Re: SOCRE Recirculated Draft Environmental Impact Report

Re: SOCRE Recirculated Draft Environmental Impact Report

Re: Comments on the Draft Environmental Impact Report

Figure 5. SDG&E's 8760-hour load duration curve used in the CAISO production simulation data base in Gridview

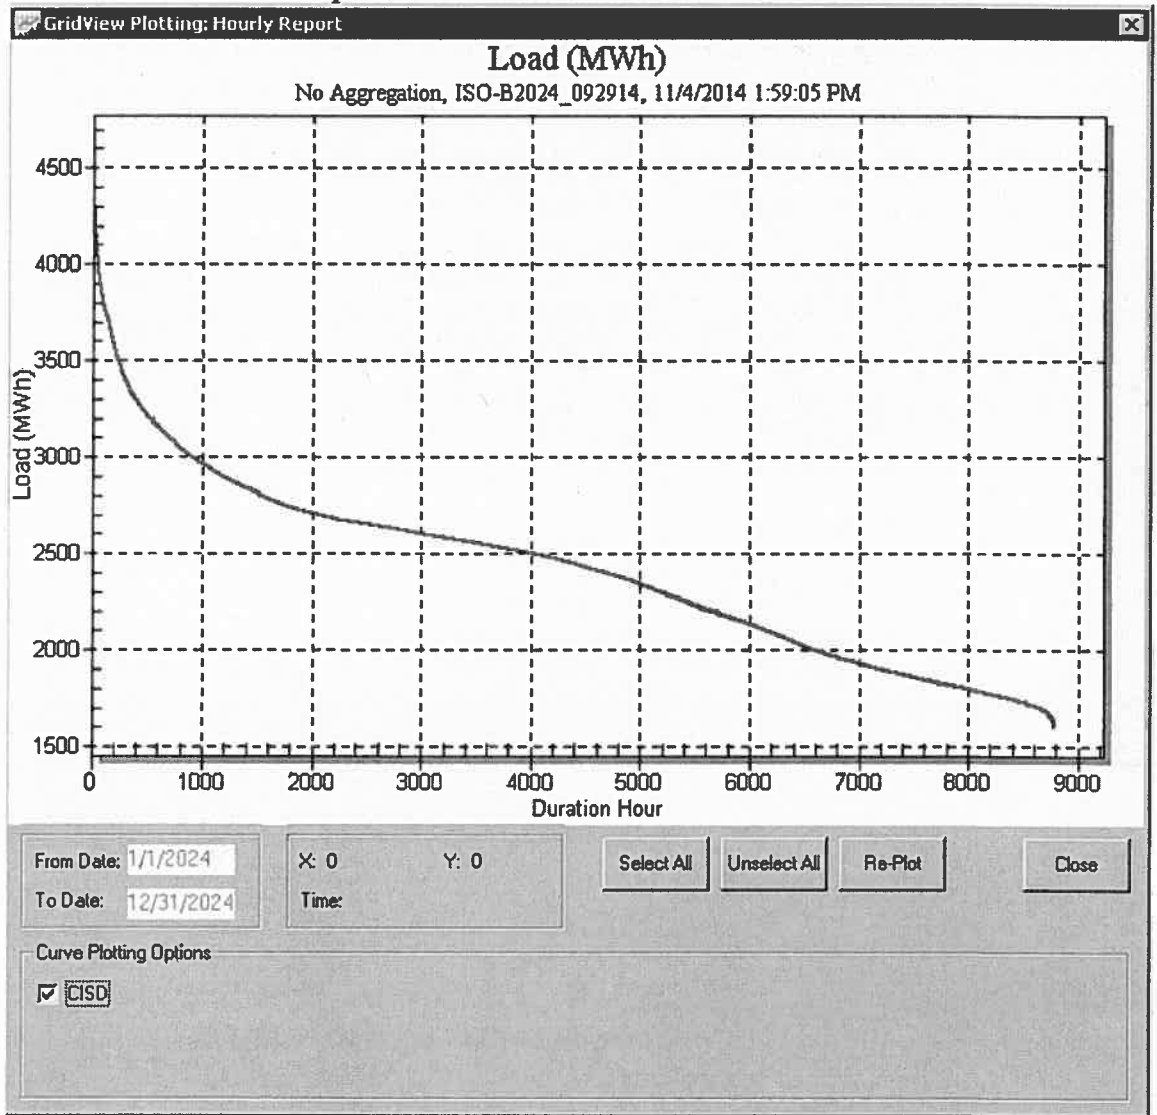
13 Moreover, even without proper implementation of the DEIR Alternative F, this
14 condition could be completely averted by scheduling the maintenance outage during the
15 times when the SDG&E South Orange County load is less than 350 MW – per CAISO’s
16 own June 17, 2015 data response to the city of San Juan Capistrano, “*If the load level is*
17 *below 350 MW when this maintenance work is performed then this reliability concern can*
18 *be avoided.*”² As the load duration curve (reproduced below) from Mr. Sparks’ May 26,
19 2015 testimony shows the duration of time whereby the SDG&E South Orange County
20 load is below 350 MW is about 8500 hours in one year allowing ample time to perform
21 this maintenance outage during a time of low enough load to avoid this condition.³
